## Determination 2009/100

# Refusal of an amendment to the fire engineering design forming part of a building consent for a multi-storey office building at 80 Queen Street, Auckland

Figure 2: Section

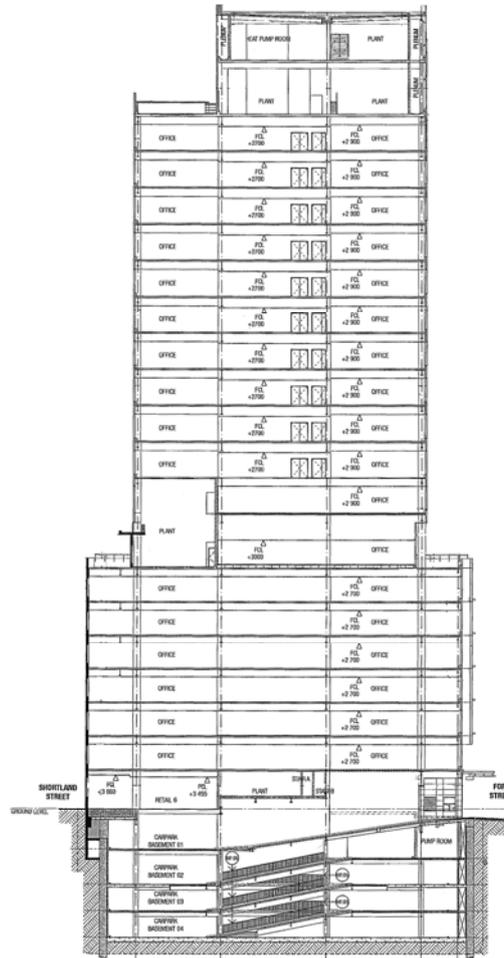
- 2.3 The steel frame to the four-level basement, as currently built and as proposed in the amended fire design, has no passive fire protection beyond its inherent period of structural adequacy. There is a concrete floor slab between the basement and the ground floor which has a 60 minute FRR.

7.2.12 For the reasons stated in 7.2.11 it is not clear that C 4.3.3 has been satisfied. The unprotected columns, beams and the consequence of any 'local instability' require proper engineering calculations to be carried out.

- (a) the proposed amended fire protection requirements to the basement steel frame do not comply with Clause C of the Building Code
- (b) the authority's decision to refuse to issue an amendment to the building consent is confirmed.
